# Access Compliance Report

## Public Rights-of-Way

Intersection ID: 45198	Main Street: PERENNIAL_TERRACE_DR	Cross Street: W_CRAIGHEAD_RD	Location: SE
ADA ID: 97ADBA62DDEC	Ramp Type: PerpDiag	Initial Pass/Fail: Fail	Overall Compliance: No
Severity Score: 22.5			
Codes/Mitigation Info/Possible Solution		Field Measurements/Component Compliance

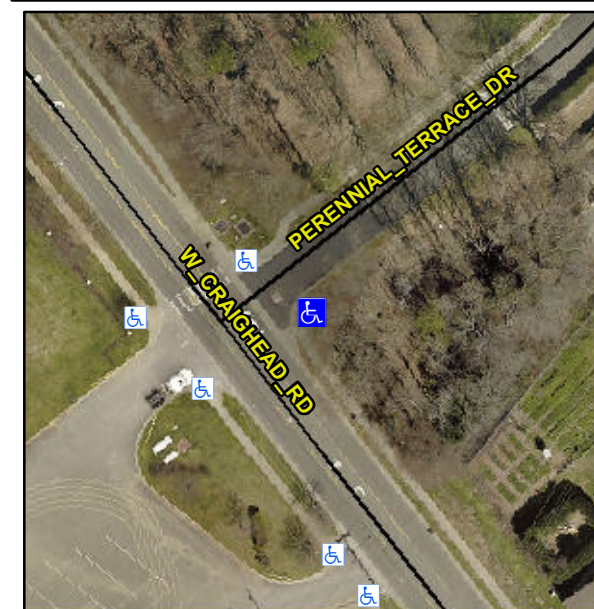
**Not Found, R304.5.1, R304.2.2, R304.5.3**

Compliance	Description	Data	Compliance	Description	Data
N/A	Ramp Length (in)	23.5	No	Ramp Slope (%)	9.4
No	Ramp Width (in)	46.0	No	Ramp XSlope (%)	5.0
N/A	Flare Type LT	N/A	N/A	Flare Type RT	N/A
N/A	Flare Slope LT (%)	N/A	N/A	Flare Slope RT (%)	N/A
N/A	Flare Traversable LT?	N/A	N/A	Flare Traversable RT?	N/A
N/A	Landing Length (in)	N/A	N/A	DWS Provided?	N/A
N/A	Landing Width (in)	N/A	N/A	DWS Contrast?	N/A
N/A	Landing Slope (%)	N/A	N/A	DWS Length (in)	N/A
N/A	Landing X Slope (%)	N/A	N/A	DWS Full Width?	N/A
N/A	Landing Curb? (Y/N)	N/A	N/A	DWS Offset (in)	N/A
N/A	Shared Landing?	N/A			
N/A	Gutter Ponding?	Yes	N/A	Gutter Slope (%)	N/A
N/A	Gutter Lip Ht (in)	0.5	N/A	Gutter X Slope (%)	N/A
N/A	Painted X Walk1?	No	N/A	Painted X Walk2?	No
	X Walk 1 Direction	To NW		X Walk 2 Direction	To SW
N/A	X Walk 1 Width (in)	N/A	N/A	X Walk 2 Width (in)	N/A
	X Walk 1 Slope (%)	1.1		X Walk 2 Slope (%)	0.6
	X Walk 1 X Slope (%)	4.0		X Walk 2 X Slope (%)	1.5

**Remove & Replace Curb Ramp With Two New Directional Ramps or Equivalent.**
